**CITY OF BLOOMINGTON
BOARD OF ZONING APPEALS (Hybrid Meeting)**

July 20, 2023 at 5:30 p.m.

BLOOMINGTON BOARD OF ZONING APPEALS
STAFF REPORT
Location: 727 W. 2nd Street

CASE #: V-18-23
DATE: July 20, 2023

TITLE: OVERALL SITE LAYOUT PLAN & PROPOSED EXHIBIT

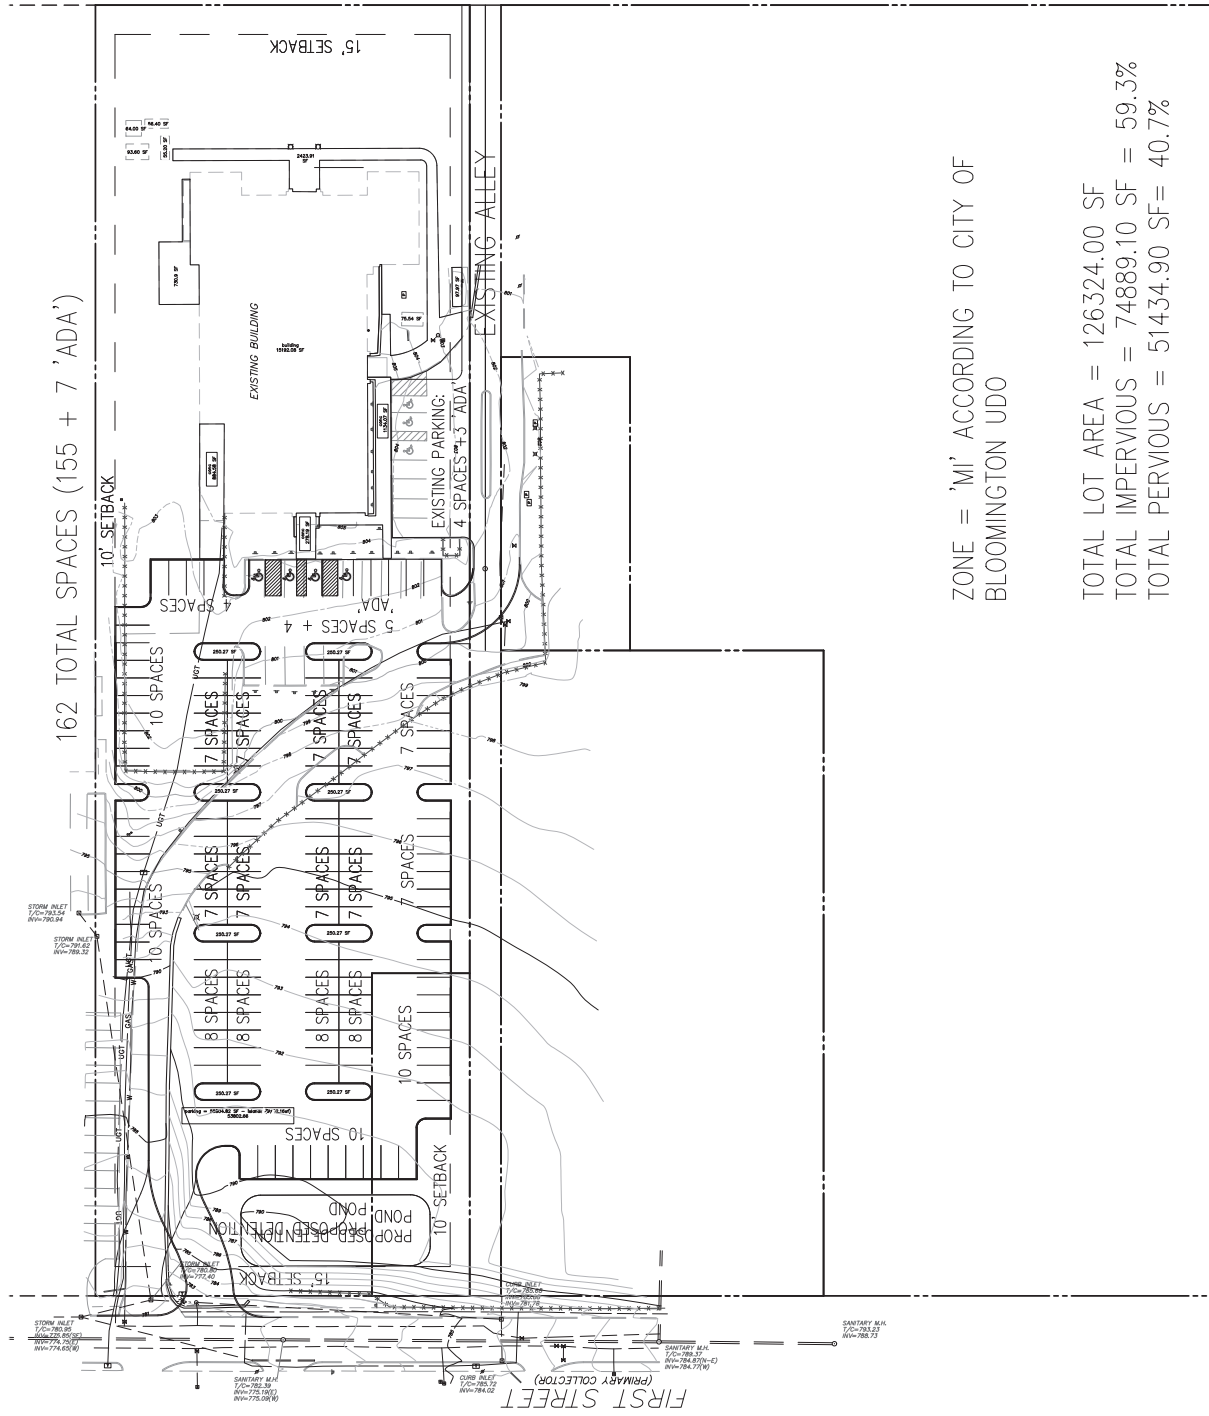
The UDO requires that parking must be set back 20’ behind the front building wall. Since the property is a through lot with frontage on two streets and the only building on the property is along 2nd Street, the petitioner is requesting a variance from the front yard parking setbacks to allow the parking area to be located between the building and 1st Street. The petitioner is also requesting a variance from Section 20.04.060(i)(5)(C) to allow 7 parking spaces to directly access the north/south alley on the east side of the property. Since the property is more than 20,000 square feet, they do not qualify for the back-out parking waiver are not allowed parking directly off of the alley. The

petitioner is also requesting a variance from the required width of a pedestrian facility and tree plot along 2nd Street to allow a 5' wide sidewalk and 5' tree plot instead of the required 10' sidewalk and 8' tree plot.

PARKING SETBACK PROPOSED FINDING: The granting of the variance to allow parking between the building and 1st Street will not be injurious to the public health, safety, morals, or general welfare of the community as the building and parking area currently exist in this configuration with no known adverse impacts. A sidewalk connection from 1st Street to the building will be required to provide pedestrian access to the building from 1st Street to offset the presence of the parking area between the building and 1st Street that limits pedestrian access.

BACK OUT ALLEY PARKING PROPOSED FINDING: The granting of the variance to allow back-out parking directly off of the alley would be injurious to the public health, safety, morals, and general welfare of the community as the intent with this standard is to require properties larger than 20,000 square feet to accommodate parking within the site since they are larger and able to install a typical parking area within the property. In addition, as part of the redevelopment of the former Hospital site it is anticipated that this alley will play a larger role in access to adjacent lots and the presence of parking directly off of the alley could cause conflicts with anticipated increased traffic moving through this area. The regulations within the TRO district require all access to come from alleys, therefore increasing the need to limit possible conflicts with turning movements and parking off of alleys in this area.

SIDEWALK AND TREE PLOT WIDTH PROPOSED FINDING: The granting of the variance to not require the sidewalk width and tree plot width outlined in the Transportation Plan and TRO would be injurious as this would conflict with the rest of the improvements that the City is proposing along this corridor. As part of the improvements along the 2nd Street corridor for the redevelopment of the former Hospital site, the City will be widening the street, improving the tree plot, and installing a new continuous sidewalk system along the entire 2nd Street corridor. The Department will work with the petitioner on coordinating and installing the required improvements along this frontage, however not requiring full compliance with the anticipated improvements would be injurious to the public health, safety, morals, and general welfare.

BACK OUT ALLEY PARKING PROPOSED FINDING: The Department does find adverse impacts on the use and value of adjacent properties by allowing parking to directly access the alley as it will increase turning movements along the alley into the parking spaces and possibly conflict with access to adjacent properties as the area redevelops. The site is large enough to provide parking internal to the site in a manner consistent with the UDO standards.

BACK OUT ALLEY PARKING PROPOSED FINDING: The Department does not find that the strict application of the terms of the Unified Development Ordinance will result in practical difficulties in the use of the property since there is a large parking area proposed within the site that meets all of the UDO requirements. There do not appear to be any practical difficulties that are peculiar to the property that require the proposed parking spaces to directly access the alley rather than internally to the site as required.

SIDEWALK AND TREE PLOT WIDTH PROPOSED FINDING: The Department does not find that the strict application of the terms of the Unified Development Ordinance will result in practical difficulties in the use of the property by installing the required 10' sidewalk and 8' tree plot. There is substantial space along the front of this property to install the required width for the sidewalk and tree plot. There do not appear to be any practical difficulties that are peculiar to the property that prevent the petitioner from installing the pedestrian improvements and tree plot as required and consistent with the improvements that the City is making along this entire corridor. Although there is a retaining wall along this frontage, it is not part of the historic character of the property and moving the wall to accommodate the required pedestrian facilities would therefore not impact the historic features of the site.

RECOMMENDATION: The Department recommends that the Board of Zoning Appeals adopt the proposed findings and approve the variance to allow parking within the front parking setback and deny the variances for back out alley parking and reduced sidewalk and tree plot width with the following conditions:

1. A sidewalk connection from 1st Street to the building is required.
2. The petitioner shall work with the City Engineering department to either dedicate the appropriate right-of-way to be improved with the City project or install improvements along the 2nd Street frontage consistent with the City's improvements.

SHEET TITLE
ELEVATIONS
SHEET NUMBER

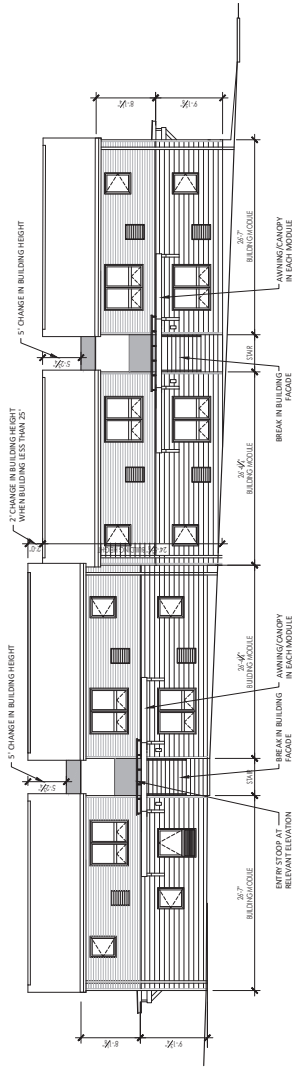
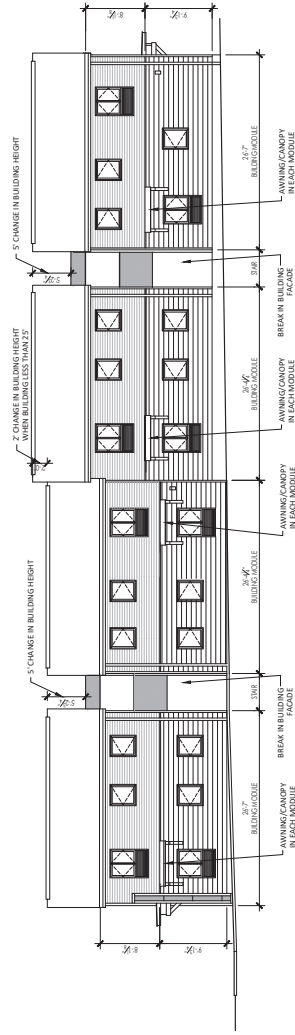
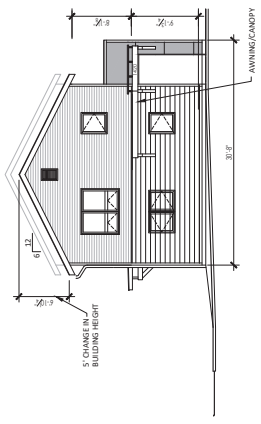
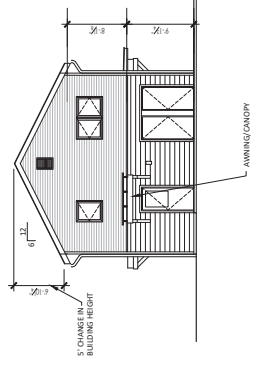
The petitioner is requesting a variance from Section 20.04.070(d)(3)(J) of the Building Design standards due to the difficulty of designing a building that meets all of the architectural standards on this narrow lot. The petitioner has been able to incorporate several elements and design features on the building to meet the desired goals of the architectural standards, however full compliance is not possible on this narrow lot with this proposed residential-style building. The petitioner has incorporated defined breaks in the height of the building along the length of the building, a change in building height of 2' at the center of the building, regular pattern of windows along all four sides of the ground floor, and included awnings along the ground floor windows and at the entrances.

Due to the long, thin proportion of the site, the architecture of the project is unable to fully meet the exterior façade provisions on the east and west sides of the building design as stated in the Unified Development Ordinance amended on 4/30/2023. We are therefore requesting a variance from the Building Design Exterior Façade provision due to practical difficulties created by the shape of the site.

The east and west elevations of the building meet two (2) of the three (3) required elements possible:

Given a building length of 116 feet, a .03% offset results in 42" on both the east and west elevations. This would leave an unrealistic building width of 18'. However, the two open stairs are visible on both the east and west sides of the building and provide the visual break in the elevations desired by the UDO. It is possible to see through the building. This change occurs within 50 feet rather than 40 feet.

The building does have entry stoops on the east and west elevations but they do not repeat within a 40' increment.

RECOMMENDATION: The Department recommends that the Board of Zoning Appeals adopt the proposed findings and approve V-19-23 with the following condition:

1. Site plan approval is required prior to issuance of a grading permit.
2. This approval is for the submitted site plan and elevations only.
